Amendments to the Drawings:

FIG. 3

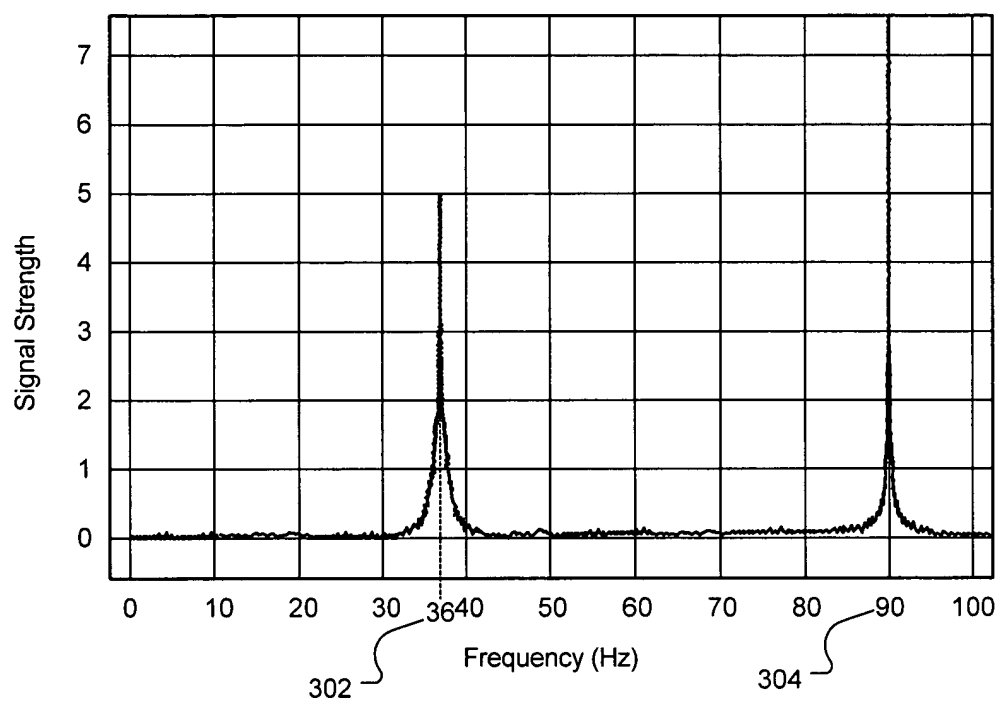
The sheets of drawings attached in the Appendix include changes to Figs. 3 and 6. These sheets replace the original sheets. The drawings have been changed as follows: Fig. 3 has been changed to reflect the correct reference number, 304, for the spindle rotation frequency. Fig. 6 has been changed to reflect the correct reference numbers for the servo-writing head, 604, and the angle δ , 618.
